Access Compliance Report

Public Rights-of-Way

(Curb Ramps)

Intersection ID: 42778	Main Street: CLEOPATRA_DR	Cross Street: SILVERSWORD_DR	Location: W
ADA ID: 9254BB9F7341	Ramp Type: PerpDiag	Initial Pass/Fail: Fail	Overall Compliance: No
Severity Score: 22.5			
Codes/Mitigation Info/Possible Solution		Field Measurements/Component Compliance

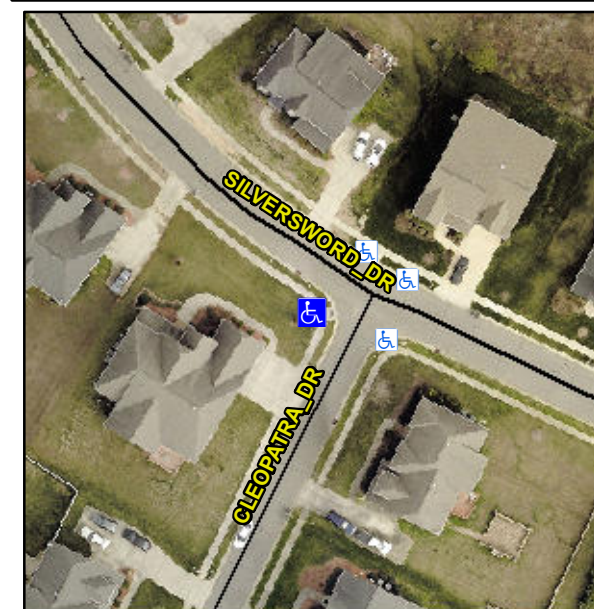
Not Found, R304.5.1, R304.2.2, R304.5.3

Compliance	Description	Data	Compliance	Description	Data
N/A	Ramp Length (in)	48.0	No	Ramp Slope (%)	9.4
No	Ramp Width (in)	47.5	No	Ramp XSlope (%)	2.9
N/A	Flare Type LT	N/A	N/A	Flare Type RT	N/A
N/A	Flare Slope LT (%)	N/A	N/A	Flare Slope RT (%)	N/A
N/A	Flare Traversable LT?	N/A	N/A	Flare Traversable RT?	N/A
N/A	Landing Length (in)	N/A	N/A	DWS Provided?	N/A
N/A	Landing Width (in)	N/A	N/A	DWS Contrast?	N/A
N/A	Landing Slope (%)	N/A	N/A	DWS Length (in)	N/A
N/A	Landing X Slope (%)	N/A	N/A	DWS Full Width?	N/A
N/A	Landing Curb? (Y/N)	N/A	N/A	DWS Offset (in)	N/A
N/A	Shared Landing?	N/A			
N/A	Gutter Ponding?	N/A	N/A	Gutter Slope (%)	N/A
N/A	Gutter Lip Ht (in)	N/A	N/A	Gutter X Slope (%)	N/A
N/A	Painted X Walk1?	No	N/A	Painted X Walk2?	No
	X Walk 1 Direction	To SE		X Walk 2 Direction	To NE
N/A	X Walk 1 Width (in)	N/A	N/A	X Walk 2 Width (in)	N/A
	X Walk 1 Slope (%)	2.2		X Walk 2 Slope (%)	2.2
	X Walk 1 X Slope (%)	0.5		X Walk 2 X Slope (%)	2.8

Remove & Replace Curb Ramp With Two New Directional Ramps or Equivalent.
